ABINGTON TOWNSHIP

PLANNING COMMISSION MEETING

**RE: Executive Summary for LD-25-02 – Redeemer Valley Farm Manure Compost Facility
PARID: 30-00-44766-00-6/ TMID: 30018 011T1
Final Minor Land Development Plans Review (1st Submission)**

**RE: LD-25-02 – Redeemer Valley Farm Manure Compost Facility
PARID: 30-00-44766-00-6/ TMID: 30018 011T1
Minor Land Development Plans Review (1st Submission)**

File Name: Redeemer Valley Farm_317.dwg
 Drawing No.: PA1
 Sheet 4 of 12

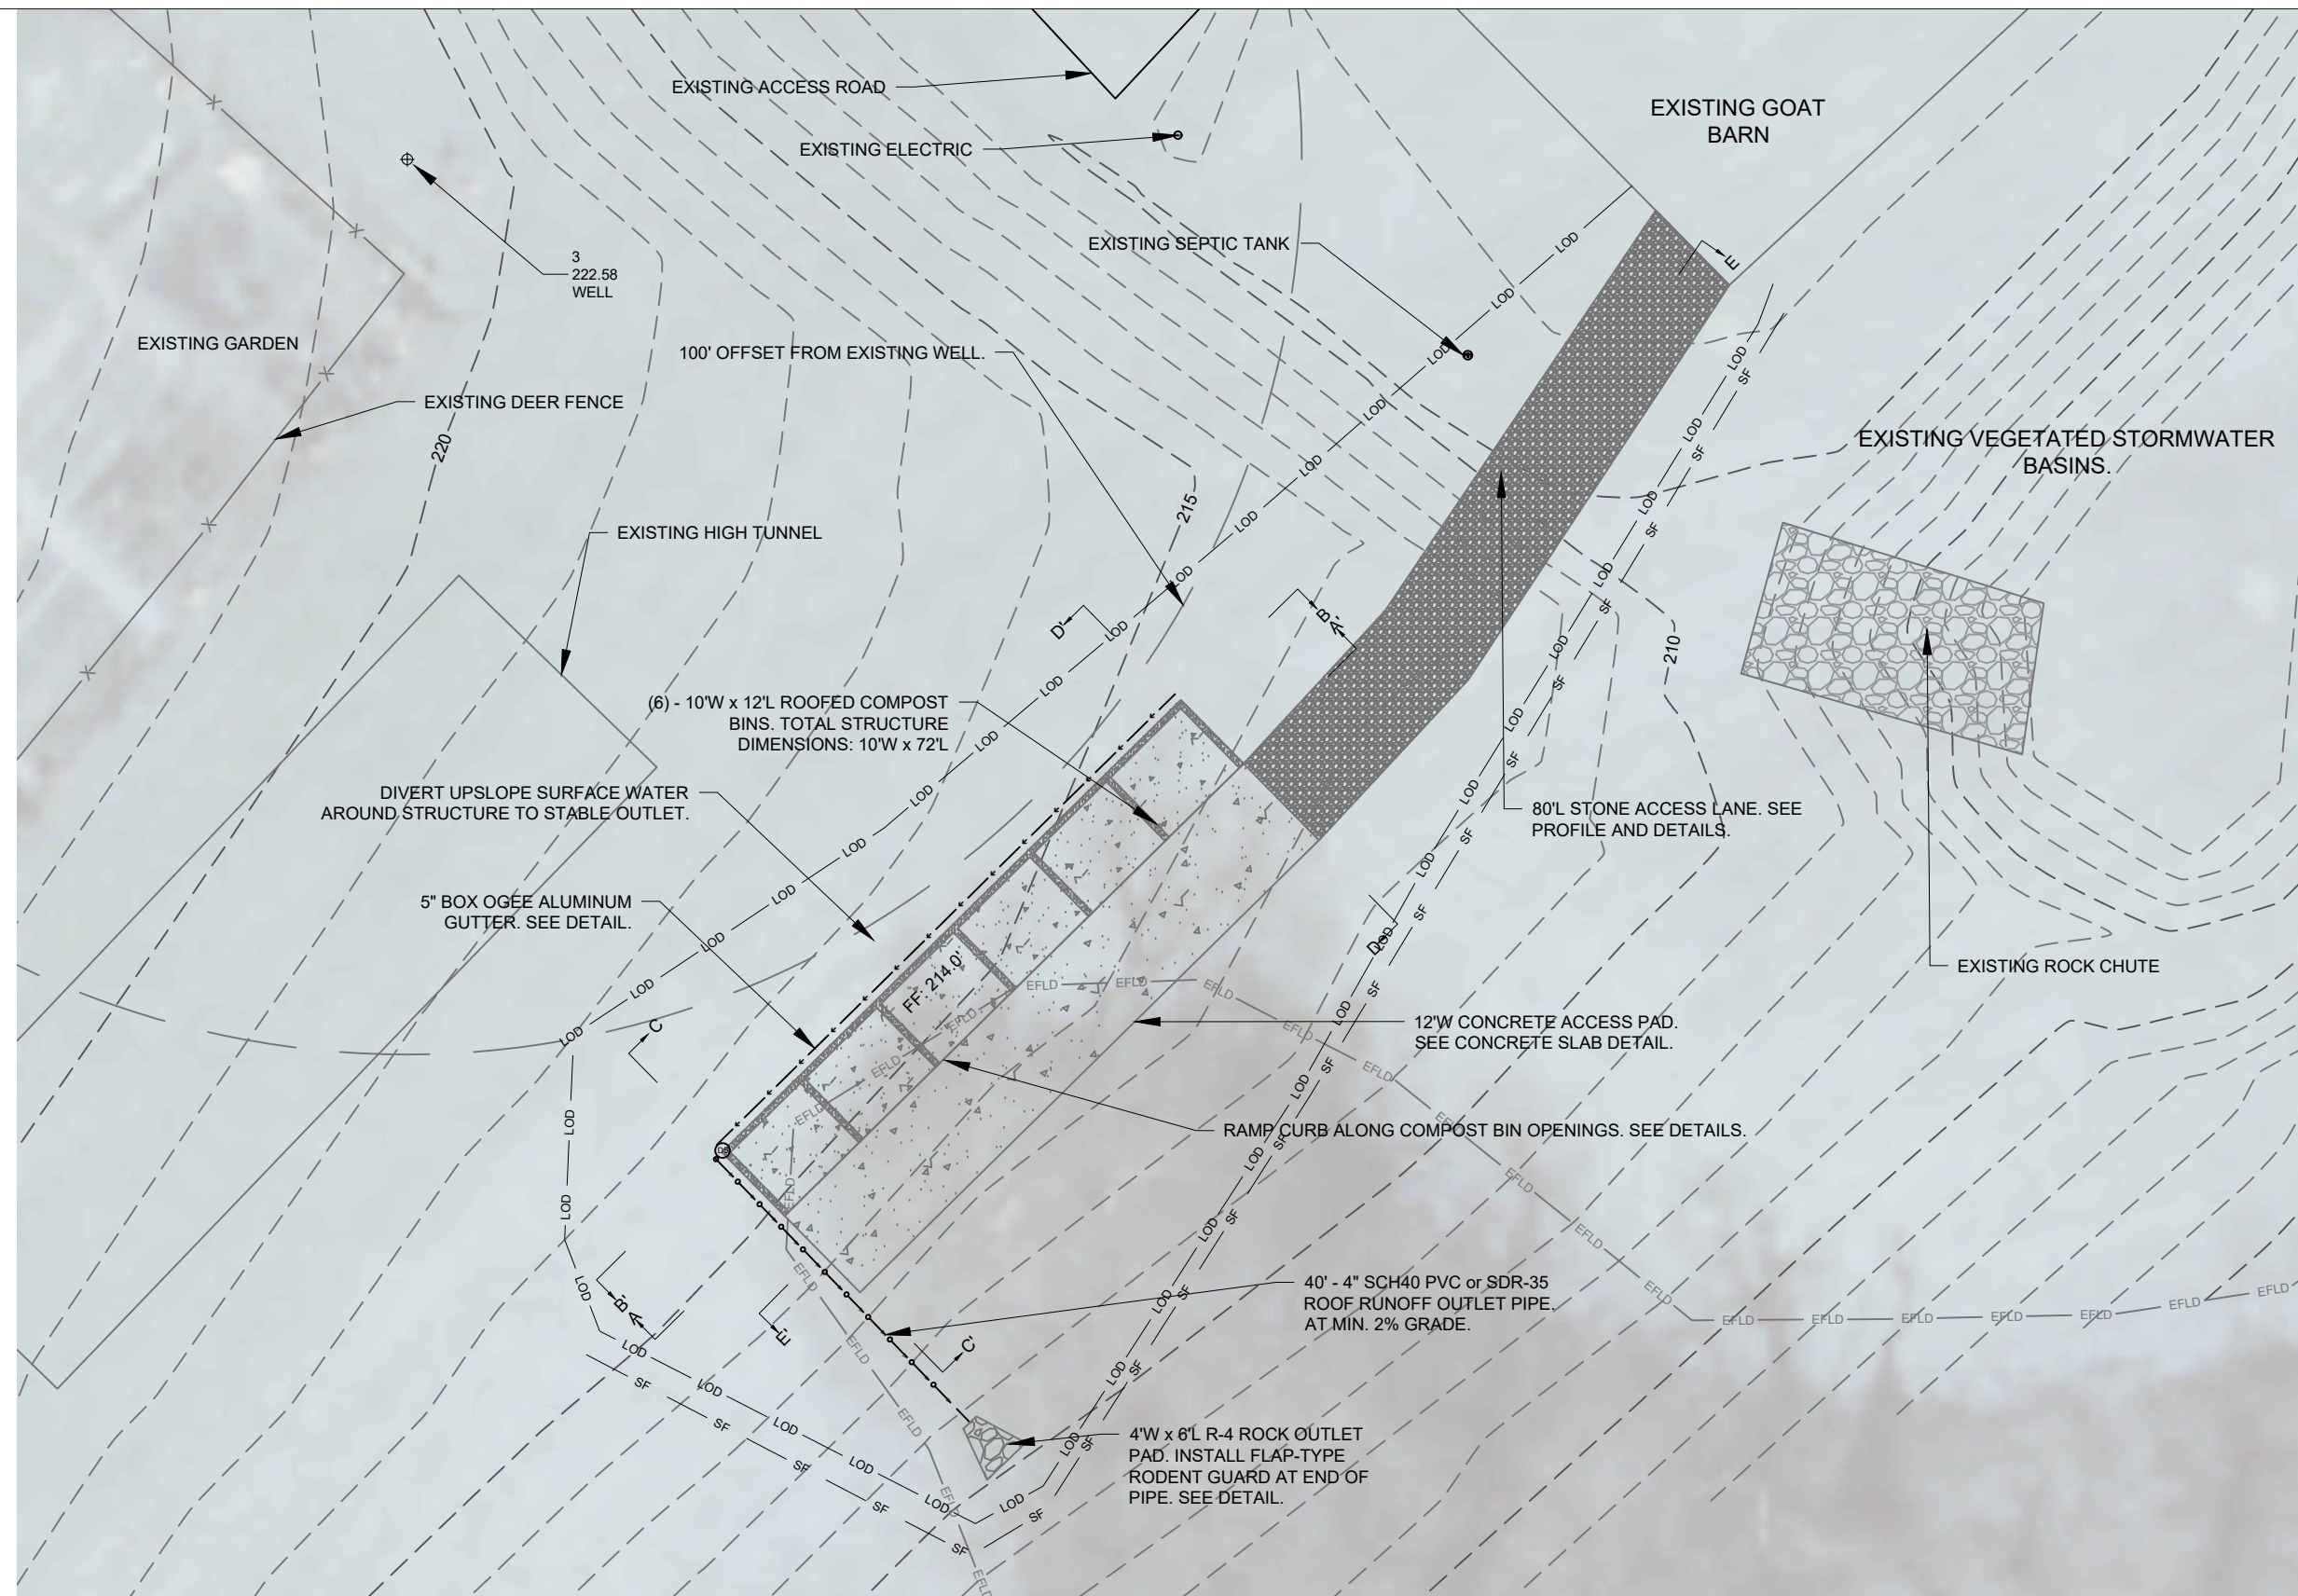
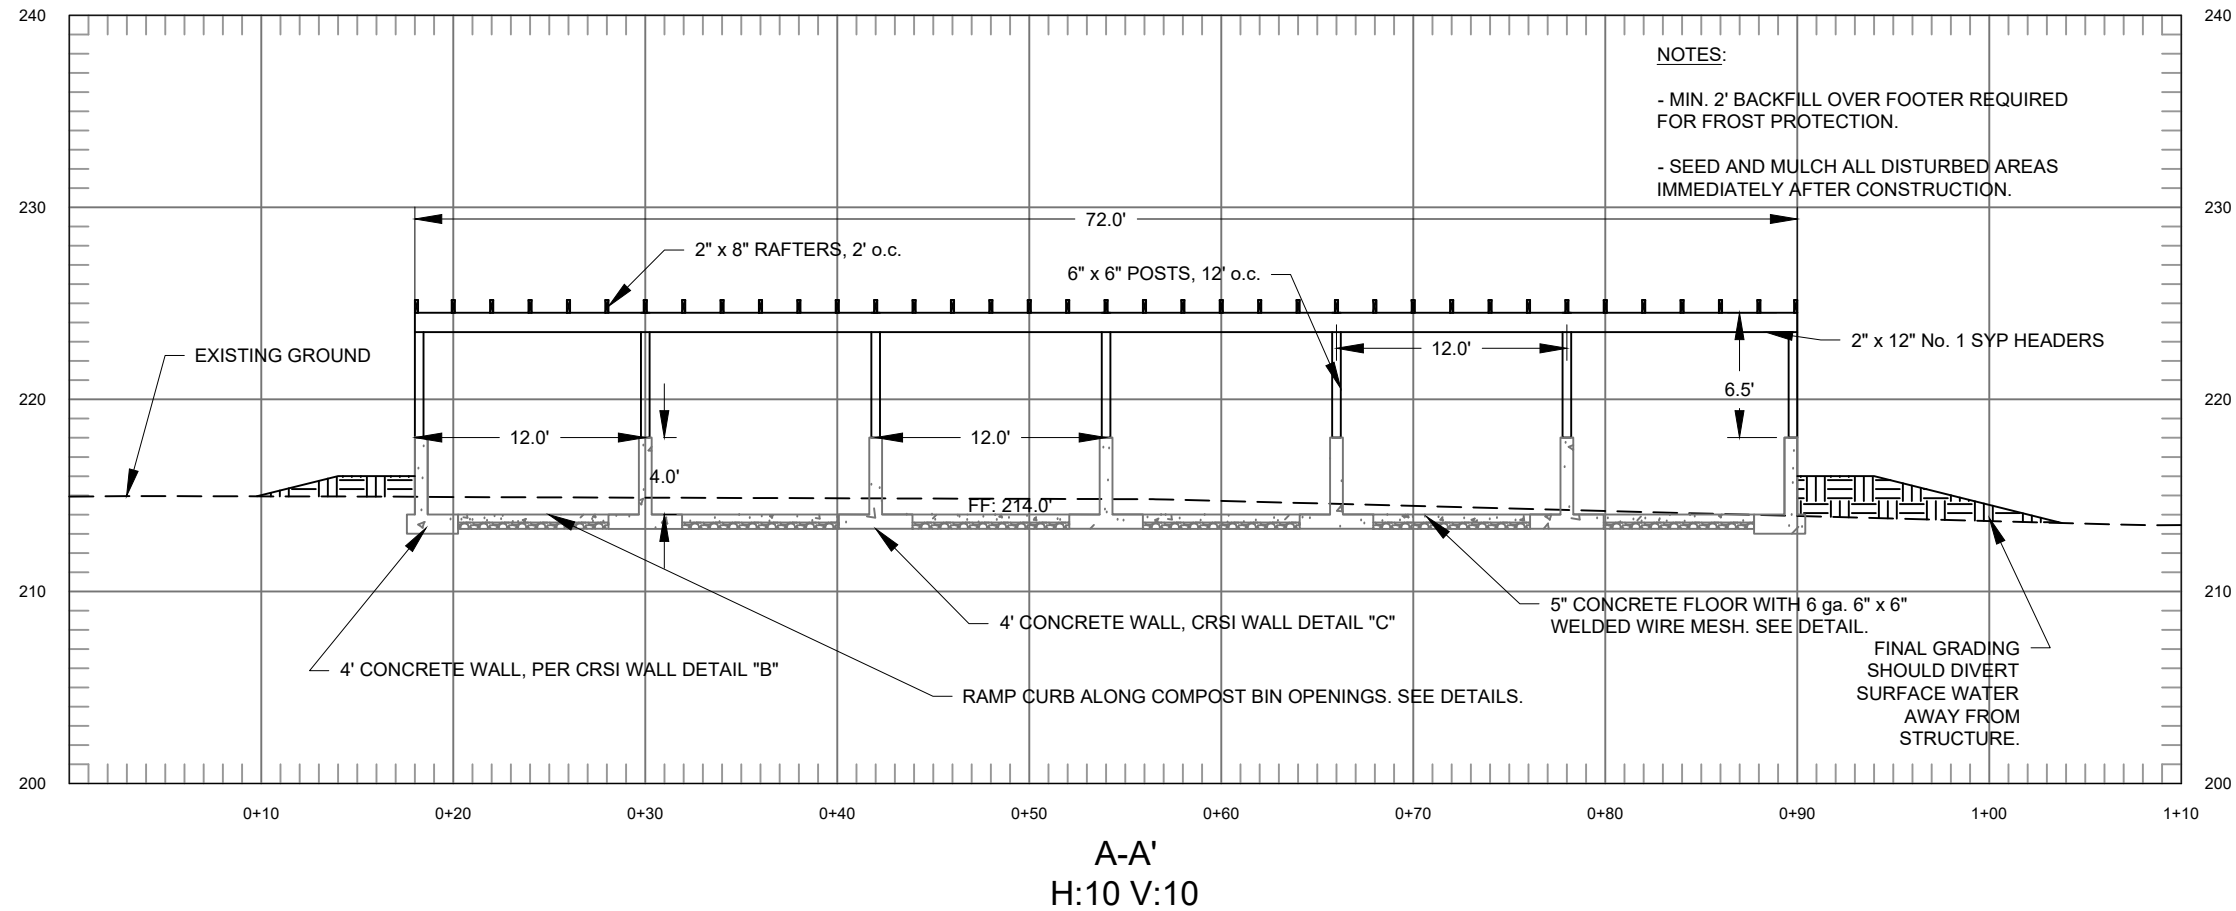
Based on the aerial of the site, there appears to be existing trees located within the vicinity of the proposed manure compost facility. These trees shall be provided on the plan, and the plan shall be updated to indicate if these trees are “TO REMAIN” or “TO BE REMOVED”.

4. **Per 2403.C Figure 24.7 – Buffers and Screening** – Any private accessory building or shed shall be buffered with a low intensity buffer.

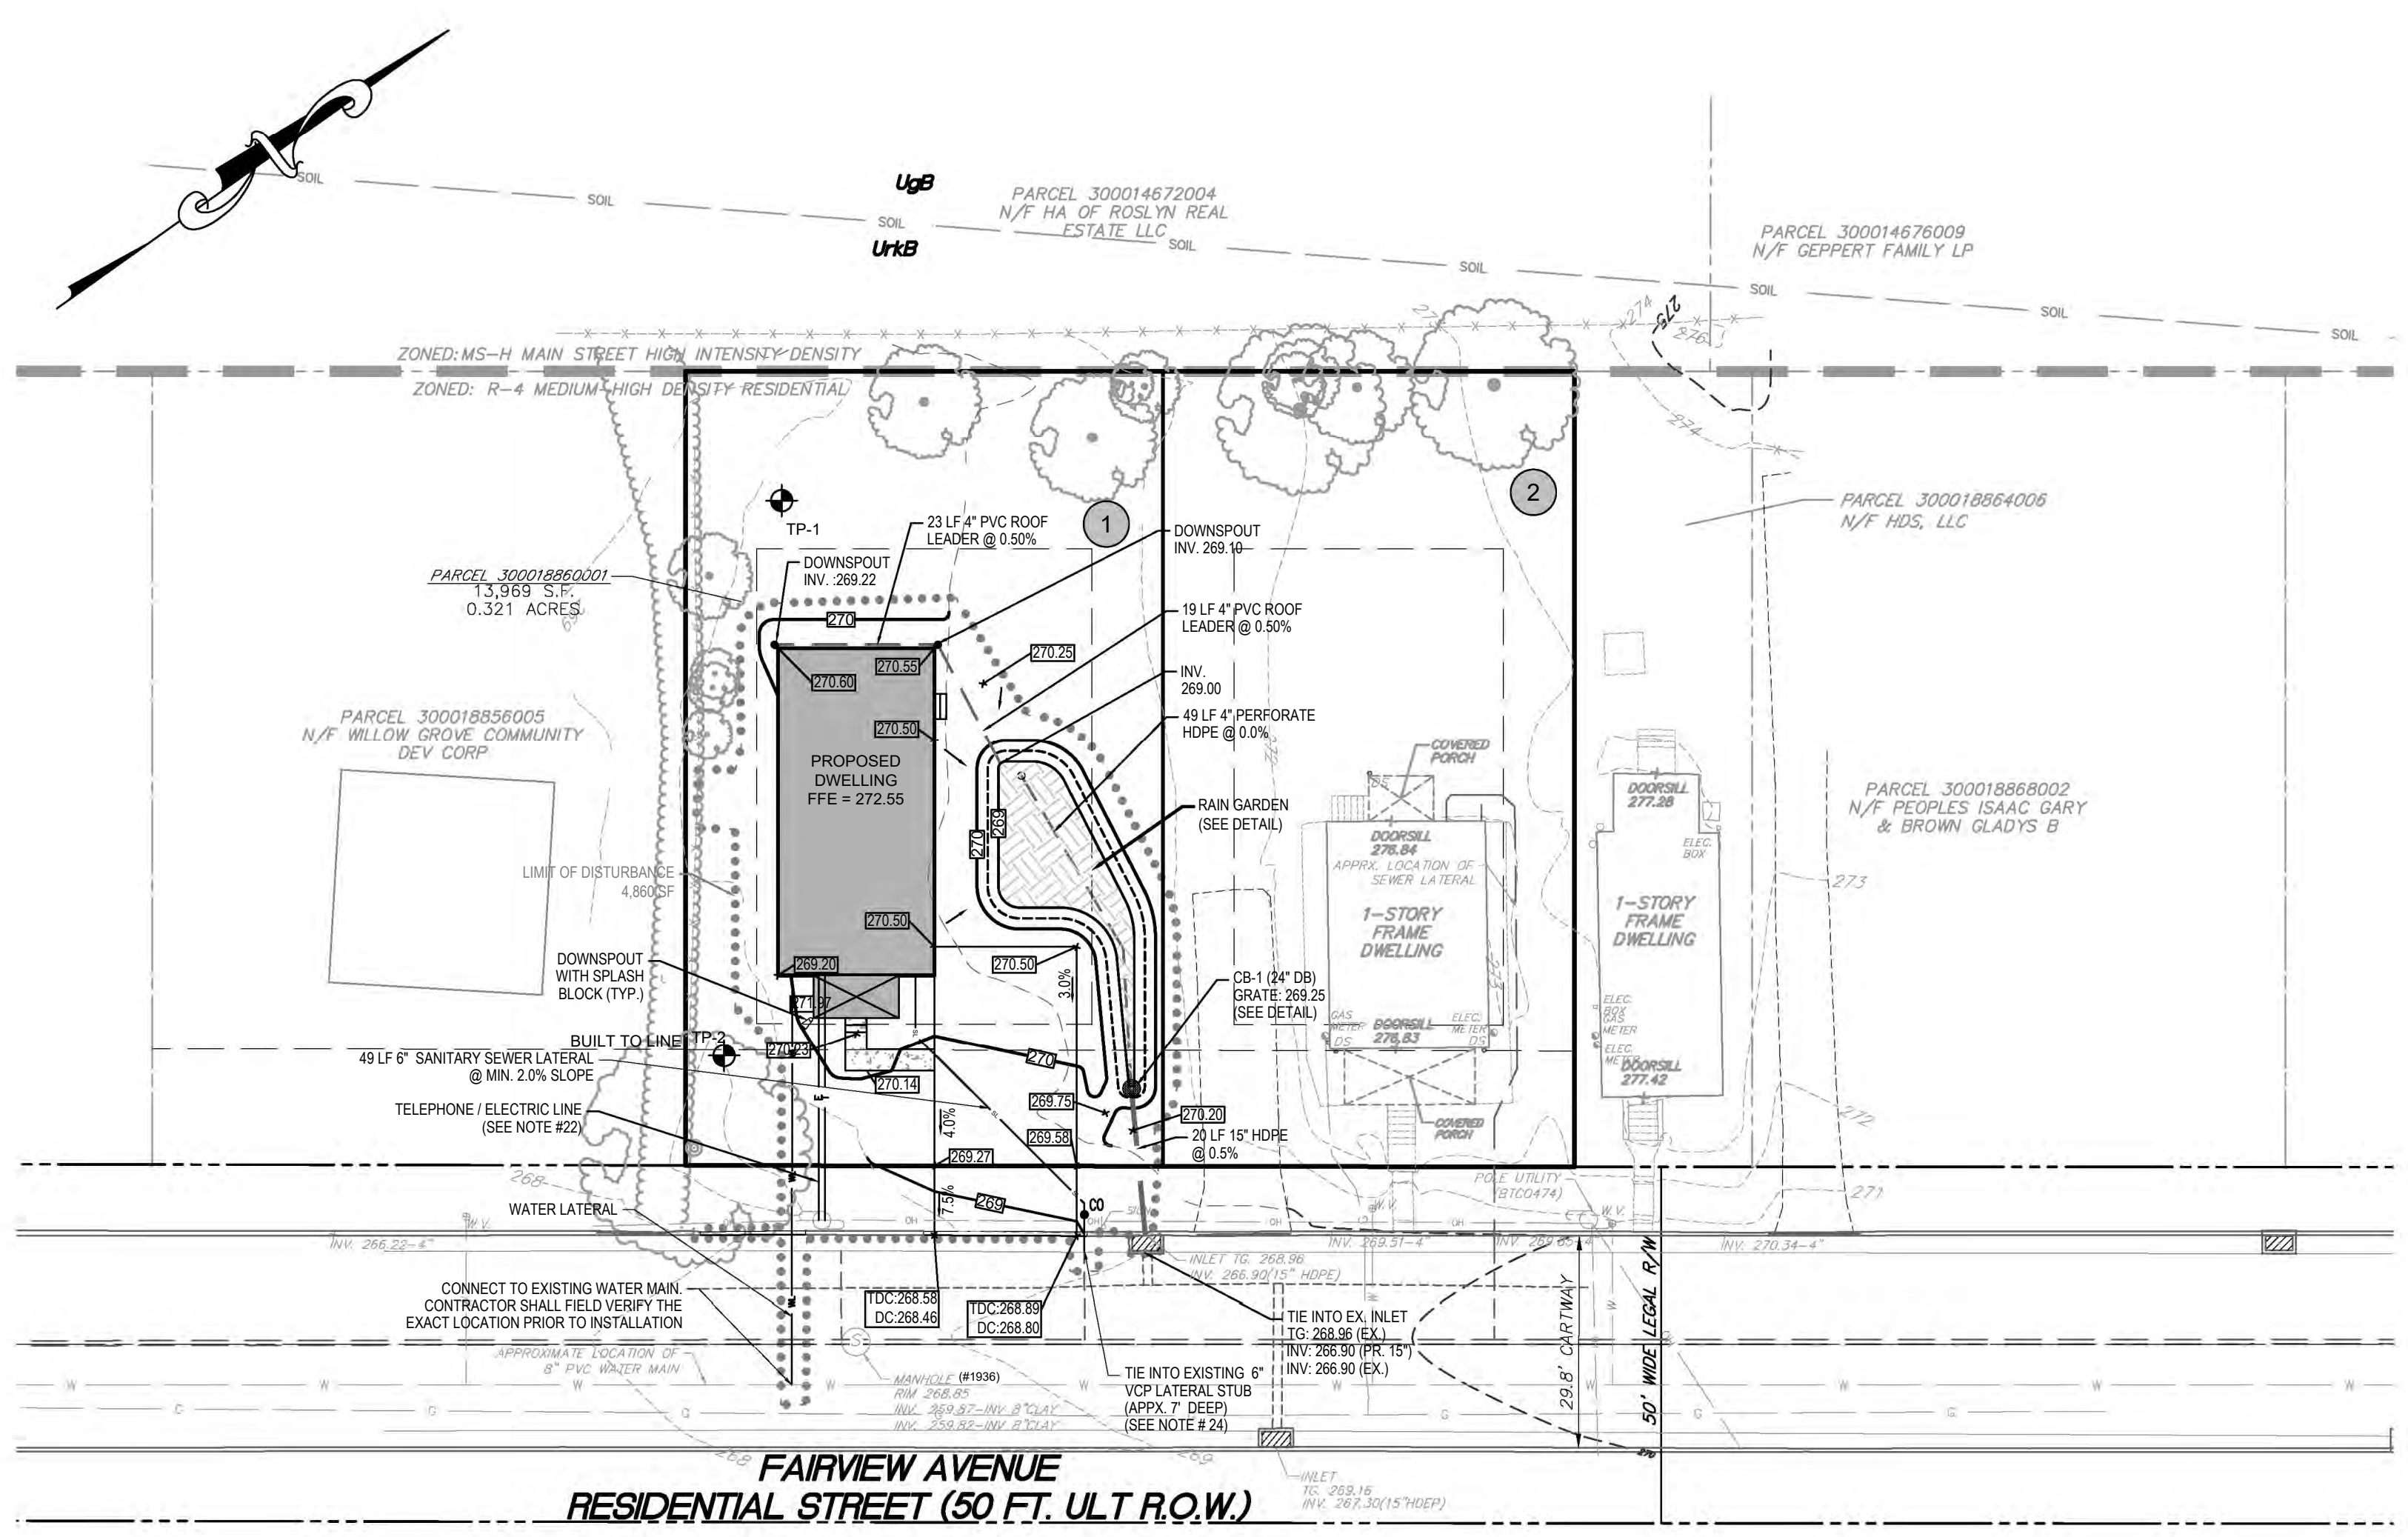
An O&M schedule and notes shall be provided on the Stormwater Plan (Sheet 5) for the proposed raingarden facility.
